SUBJECT: NuScale Power, LLC Response to NRC Request for Additional Information No. 136 (eRAI No. 8933) on the NuScale Design Certification Application

eRAI No.: 8933

NRC Question No.: 03.07.02-17

Figure 1-29. RXB - East-West (X) ISRS, Node 27692, Crane Rail Slab between Grid Lines RX-4 and RX-5 at El. 145'-6", Capitola Input.

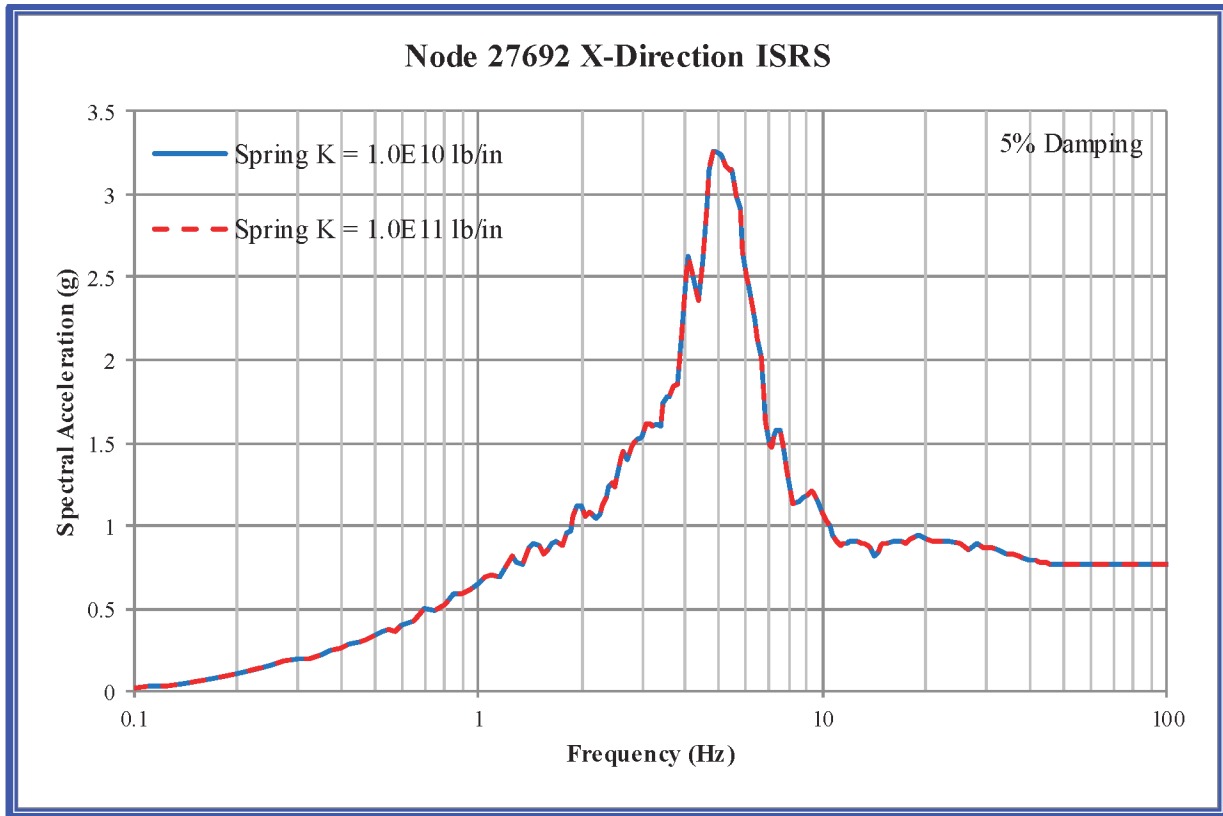
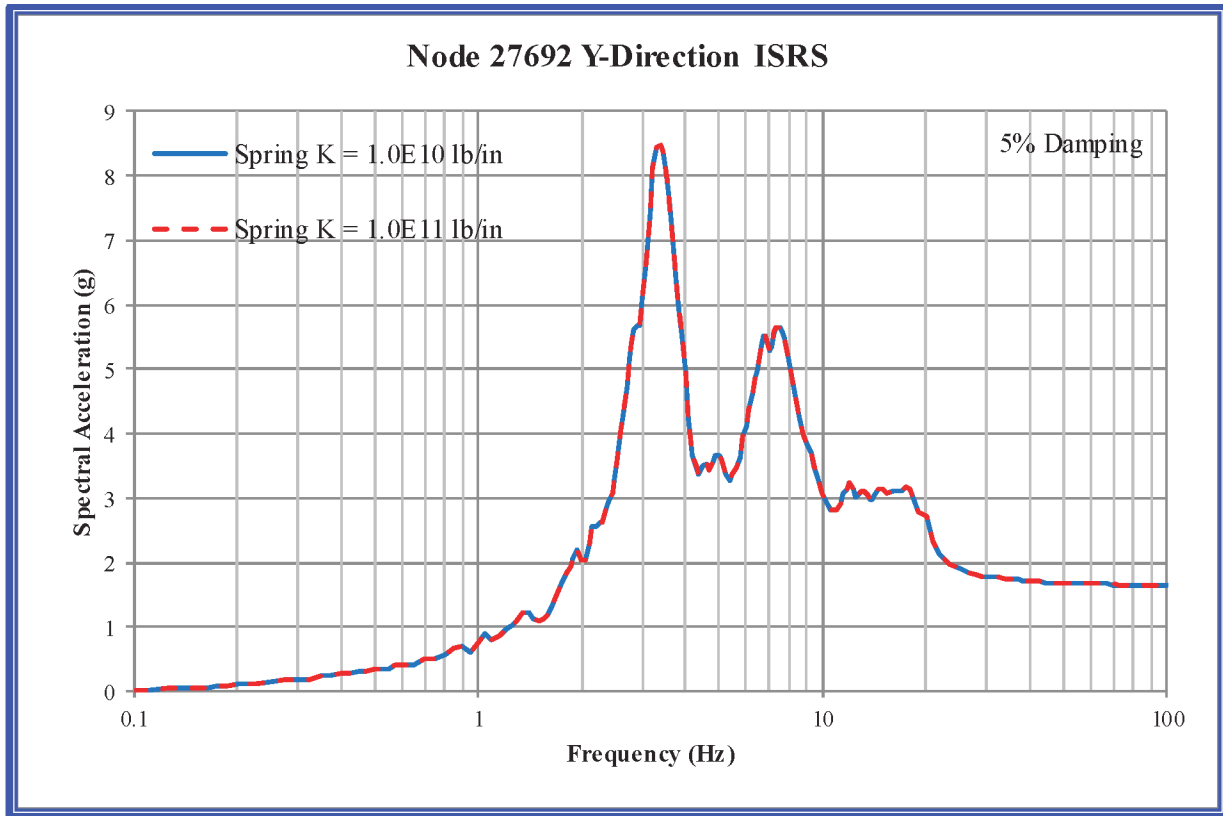
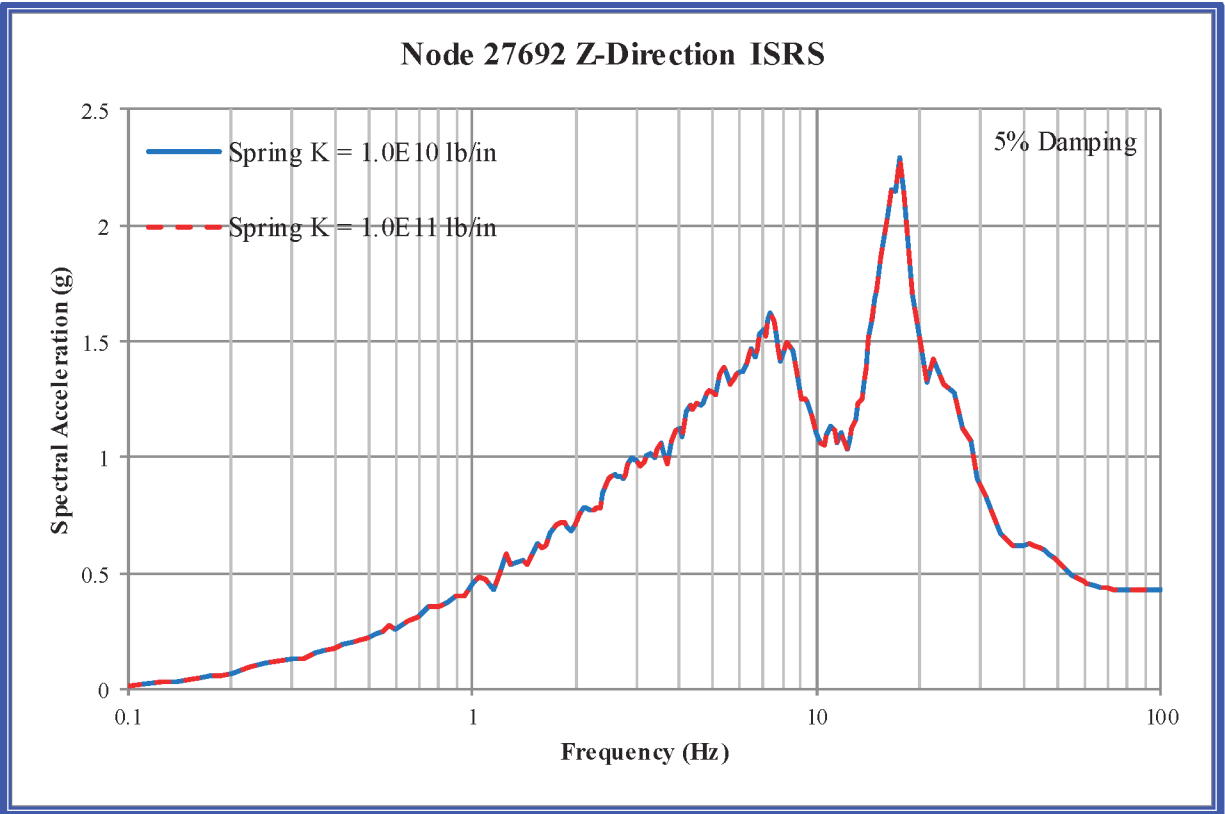
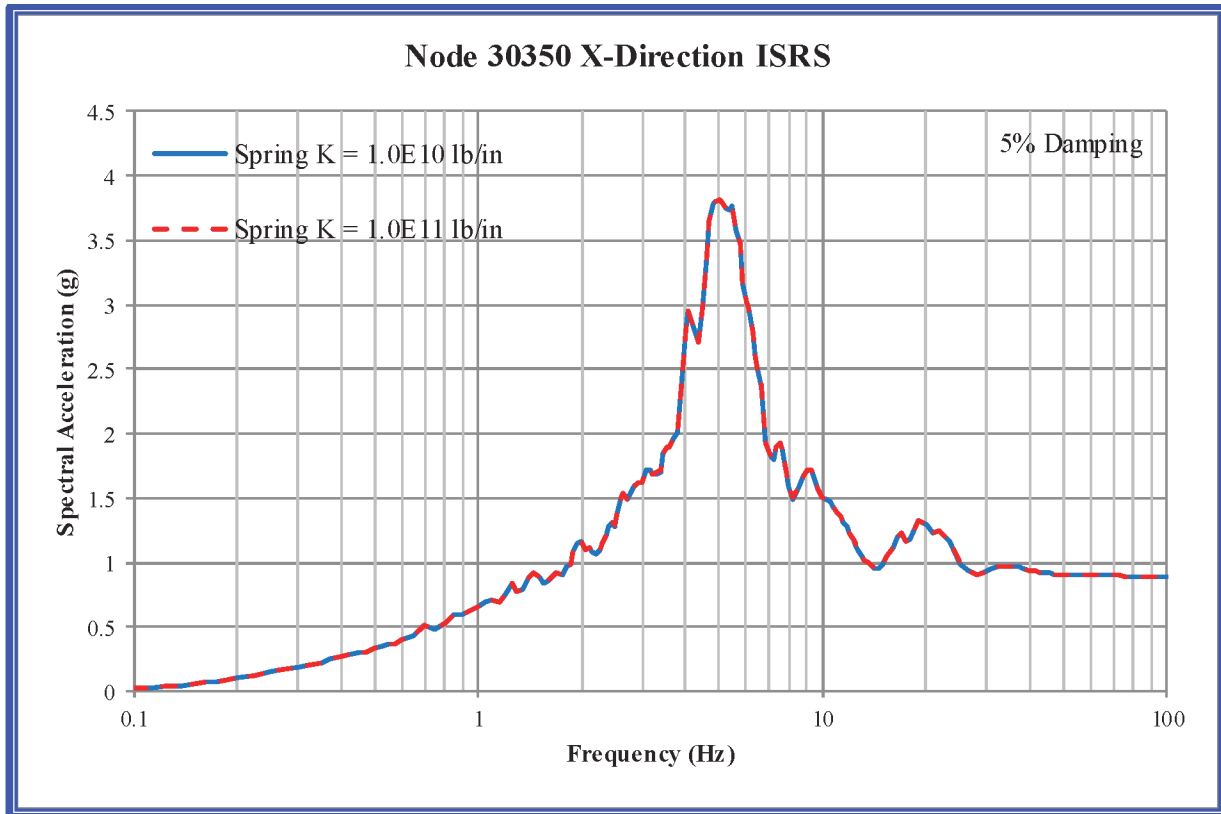
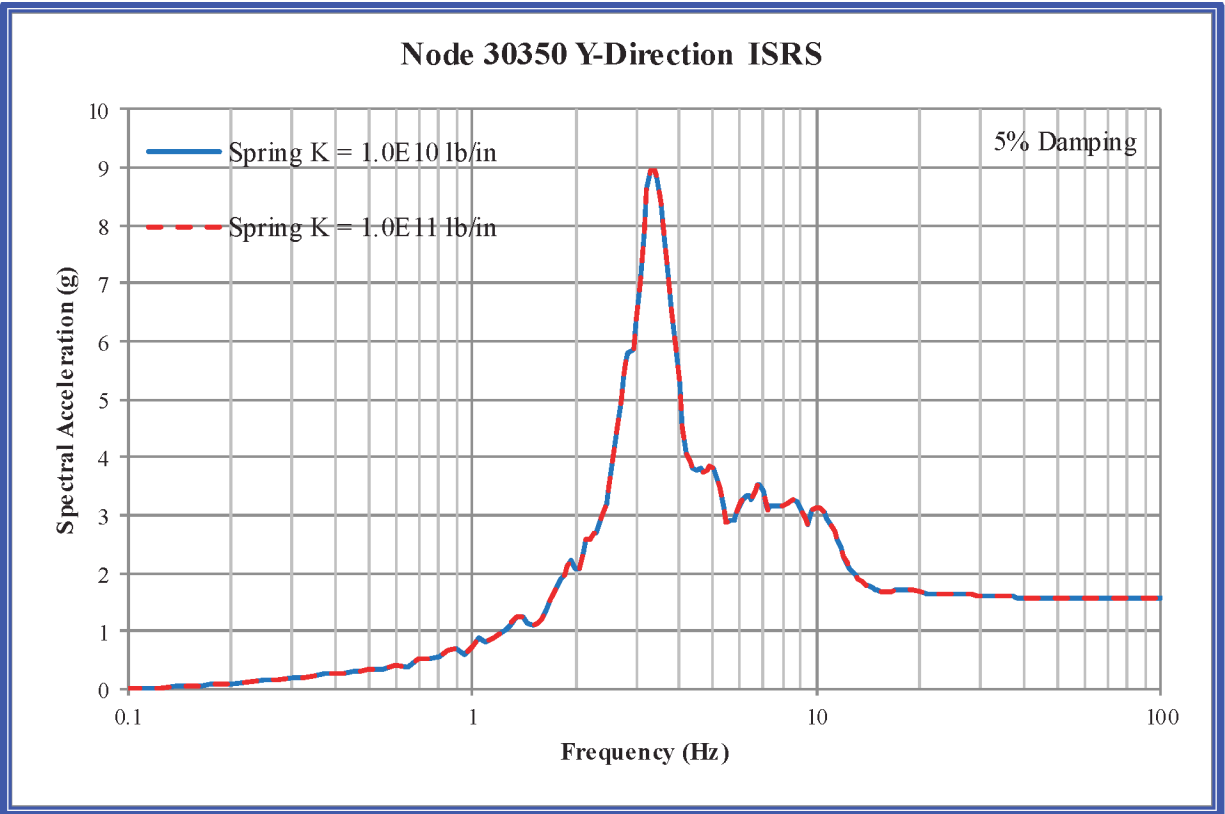
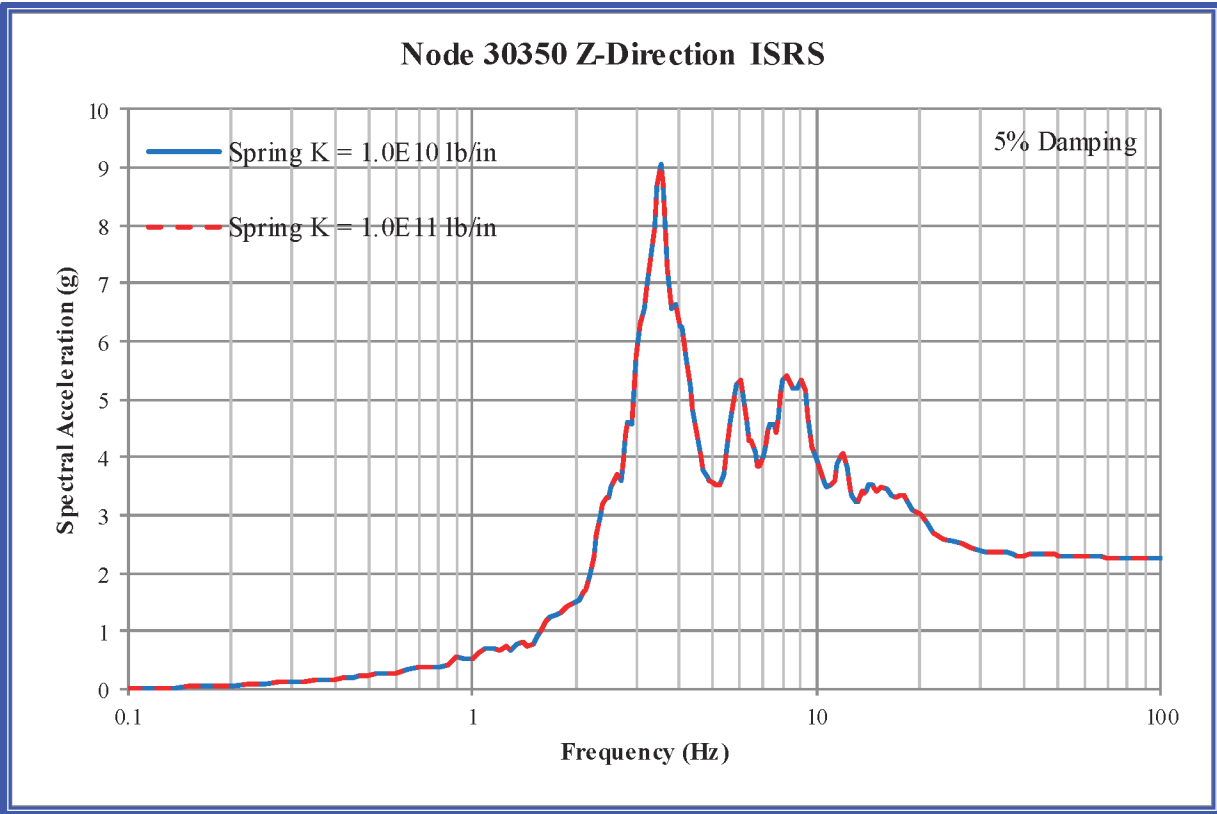
- b. On Page 3.7-25 of the FSAR, in the sixth paragraph, the applicant states, “The rigid springs have a zero length and have a stiffness value large enough to simulate rigid connection. The large stiffness used is arbitrarily chosen to be ten billion lbs per inch, or 1010 lbs/inch, in the three global directions.” For the spring to be modeled as a rigid spring, the value of its spring constant should be sufficiently larger than the stiffness of the structural element (basemat) to which it is attached. The applicant is requested to confirm the adequacy of the number (1010 lbs/inch) chosen for the spring constant by comparing it to the stiffness of the adjacent basemat element or through an appropriate sensitivity run using a number at least an order of magnitude different.

The ISRS comparisons are shown in Figure 1-20 through Figure 1-34. There are no discernible differences in the ISRS generated with spring $K = 10^{10}$ lb/in and spring $K = 10^{11}$ lb/in.
